HISTORIC AND DESIGN REVIEW COMMISSION

HDRC CASE NO: 2017-633
ADDRESS: 413 N PINE ST
LEGAL DESCRIPTION: NCB 578 (120 BOSTON ST), BLOCK C LOT 10
ZONING: RM-4, H
CITY COUNCIL DIST.: 2
DISTRICT: Dignowity Hill Historic District
APPLICANT: Rick Archer
OWNER: Benjamin Bowman
TYPE OF WORK: Amendment to a previously approved design to include partial demolition, porch replacement and construction of a side addition
APPLICATION RECEIVED: December 01, 2017
60-DAY REVIEW: January 30, 2018
REQUEST:

The applicant is requesting conceptual approval to:

413 N PINE ST
GROUND FLR PLAN

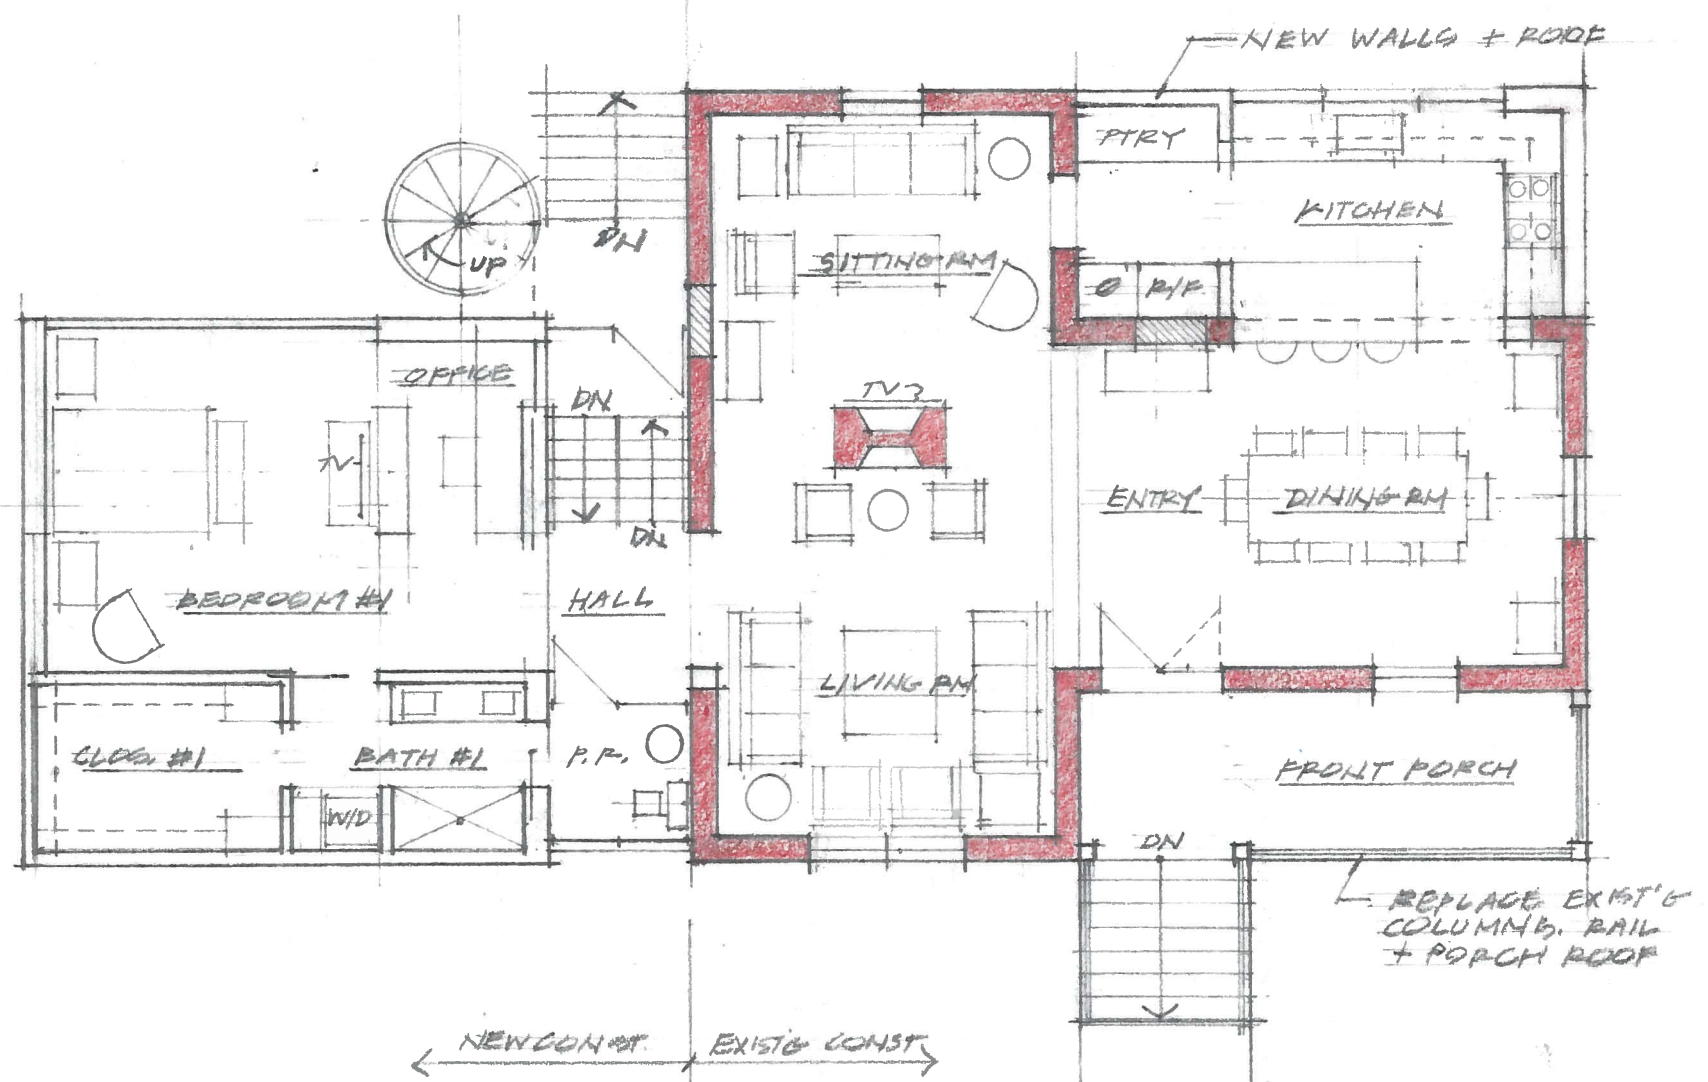
- g. **SIDE ADDITION AMENDMENT** – While a non-contributing addition has previously been constructed to the side of the historic house, any replacement addition should continue to seek conformance with the historic design guidelines and should be designed as to not distract from the original construction. The previously-approved replacement addition consisted of a modest, shed-roof form that met the Guidelines and was subordinate to the historic, stone house. The current application proposes to dramatically increase the footprint, massing, and height of the side addition.

- h. **SIDE ADDITION DESIGN** – According to the Guidelines for Additions, new additions should be sited at the side or rear of the building whenever possible to minimize views of the addition from the public right-of-way. Additions should be subordinate to the principal façade of the original structure in terms of their scale and mass,

and should feature similar roof forms and compatible materials. The proposed addition features a flat roof with a terrace and railing, wood siding, limited fenestration on the front façade, and a cantilevered portion on the south end that extends over a subgrade parking area. While the overall form of the proposed addition aids to provide a clear visual transition between the old and new construction, the siting and scale in relation to the front façade distracts from the historic house. The proposed side addition is in the same plane as the front façade and should be set back substantially or repositioned to the rear of the house consistent with the Guidelines. The addition should also seek to incorporate more compatible materials, roof form, and fenestration patterns that are complimentary of the historic house. The proposed side addition is a significant departure from the historic design guidelines in terms of siting and overall design and is not appropriate. Given the age and significance of the historic house, a more respectful addition should be considered.

4. Staff does not recommend approval of the proposed side (south) addition. This proposed addition is not appropriate and should be redesigned to be subordinate to the historic house consistent with the Historic Design Guidelines.
5. Staff does not recommend approval of item #5 at this time. Staff recommends the applicant continue to explore mounting location that would not result in the solar panels being located on a primary roof slope of the historic structure where visible from the public right of way.
6. Staff recommends that any non-original windows be replaced with architecturally appropriate windows that match the profile of the historic wood windows found in the structure. Additionally, staff recommends that all historic wood windows be repaired.

413 N PINE ST.
EAST ELEVATION
1/8" = 1'-0" 11.26.17

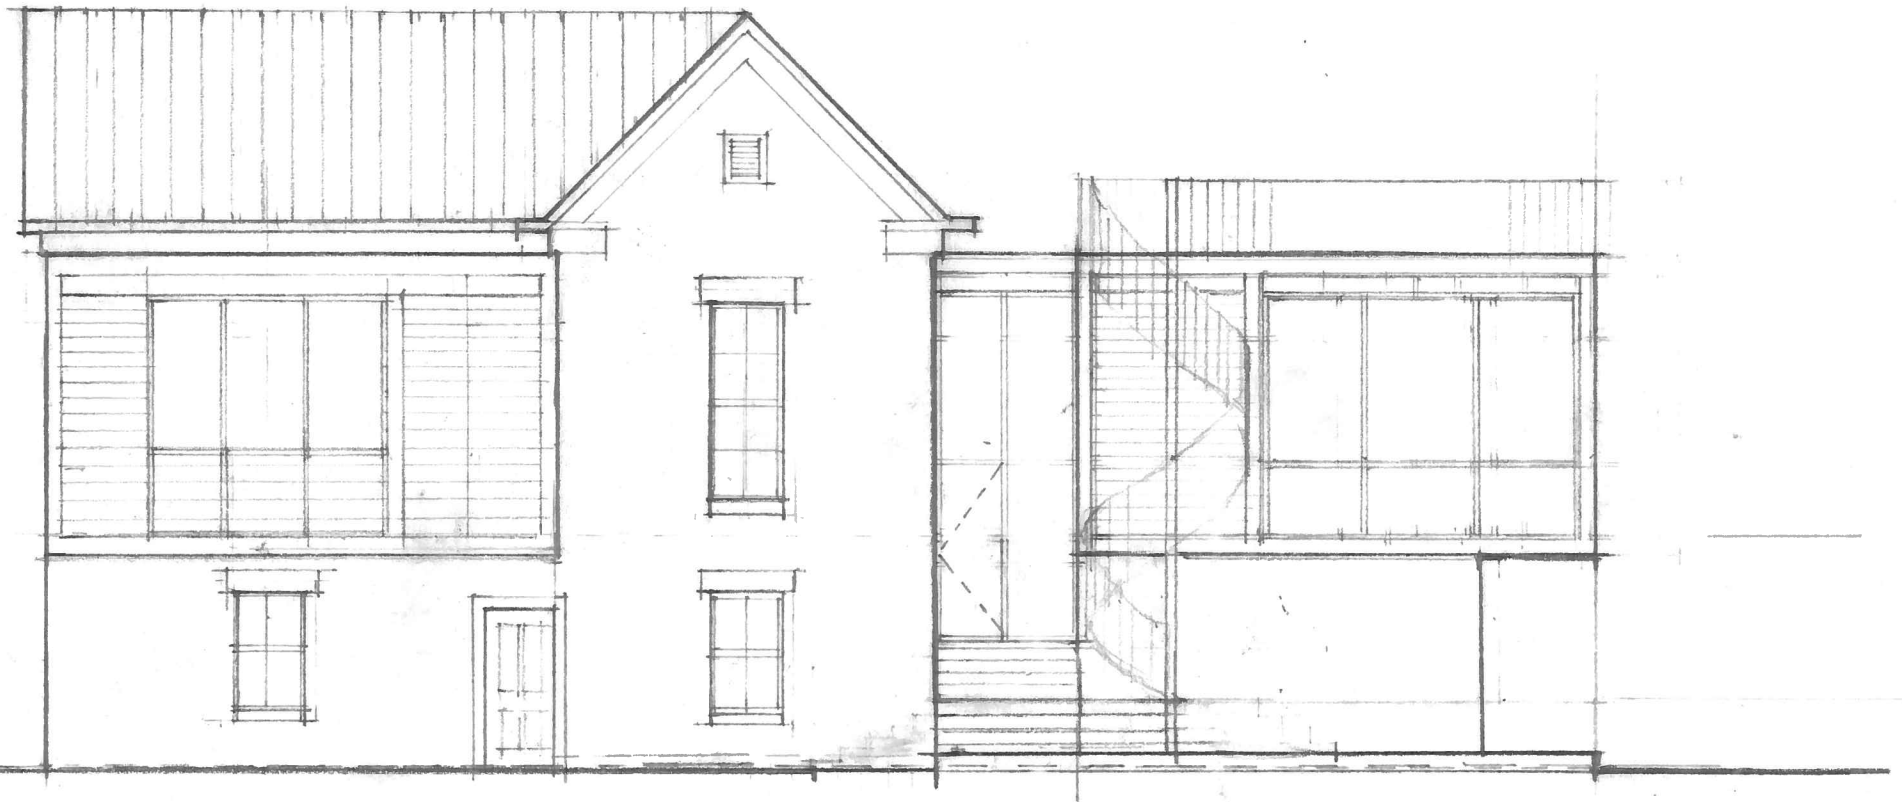
- k. **FRONT PORCH MODIFICATIONS** – The applicant has provided a structural report noting that approximately 70 percent of the roof structure’s material is no longer structurally sound or has experienced significant deterioration. The applicant has proposed to reconstruct the front porch roof structure; however, the applicant has proposed to reconstruct this structure by using an exposed steel structure and flat roof. Staff finds the reconstruction of the existing porch roof to be appropriate to repair and replace damaged elements; however, materials that match the existing should be used. The porch should be reconstructed to match the existing, original profile.

413 N PINE ST
WEST ELEVATION
1/8" = 1'-0" 11.26.17

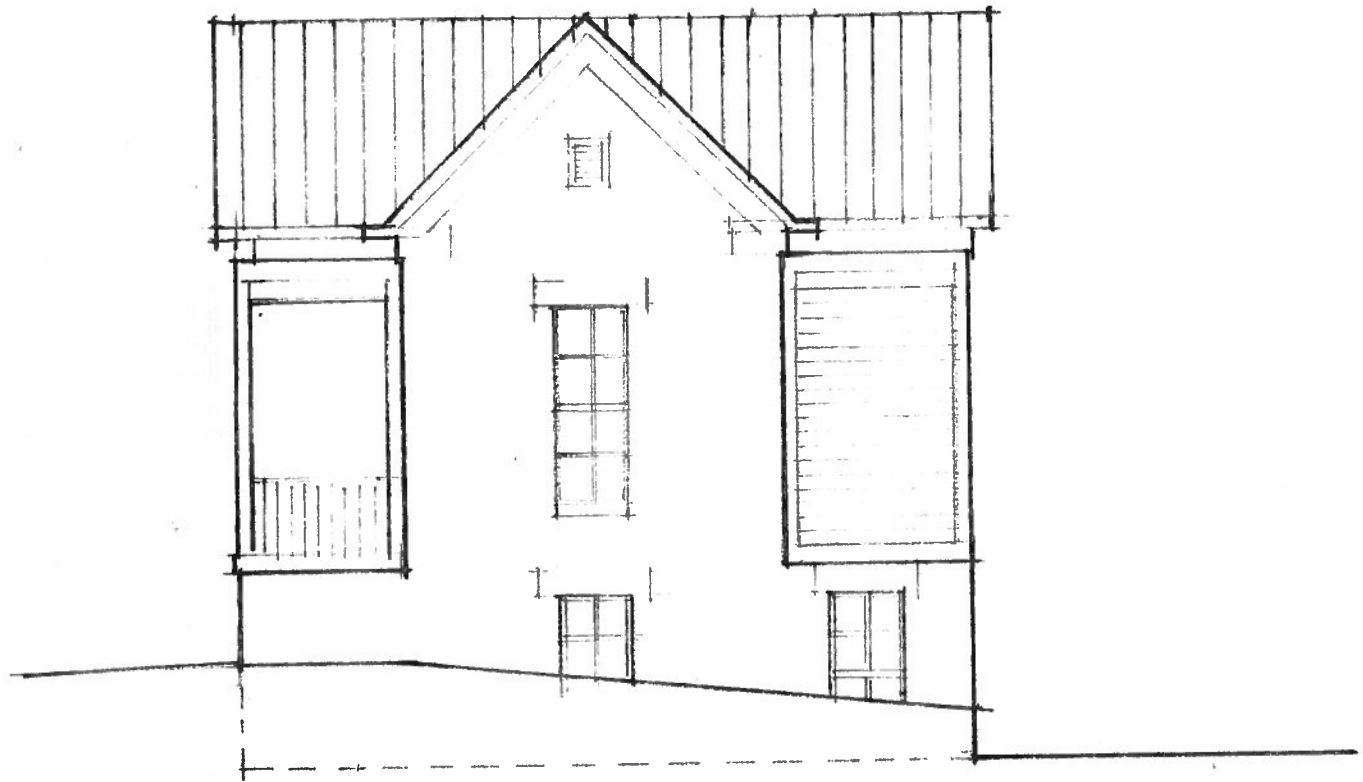
- e. **DEMOLITION OF EXISTING ADDITION** – The applicant has proposed to demolish the walls and roof of a rear (west façade) addition and to reconstruct the addition to feature a modified roof and cladding materials. The applicant has provided an engineer's report that notes that this portion of the structure is not original due to construction materials and methods that differ from those the historic structure. The engineer's report also notes that the structural integrity of the addition has been compromised. This rear addition does not appear until the 1951 Sanborn Map and appears to have originally been an open air porch. Staff finds the removal and reconstruction of the non-original walls to be appropriate.

- f. **RECONSTRUCTION OF REAR ADDITION** – The applicant, per conceptual construction documents has proposed to reconstruct the rear walls of the addition as they currently exist; however, the applicant has proposed a flat roof to replace the existing shed roof. The Guidelines for Additions 1.A.iii. notes that similar roof forms, including pitches, form, overhangs and orientation should be used when constructing an addition to a historic structure. Staff finds the flat roof to be inconsistent with the Guidelines.

1. Staff recommends conceptual approval of item #1, the demolition of the addition constructed on northwest corner of the historic structure and replace the walls and roof of a previously enclosed porch with a new addition with the following stipulations:
 - i. That the addition feature a cladding material more appropriate for a plaster and masonry façade and not wood siding.
 - ii. That the addition feature a sloped roof structure.
2. Staff recommends conceptual approval of item #2, the reconstruction of the front porch with the stipulation that the profile of the porch, including height, massing, materials and roof slope remain as is.
3. Staff does not recommend approval of stucco replacement at this time. Staff recommends that appropriate specifications are submitted to staff for administrative approval. Cementitious stucco is not recommended.
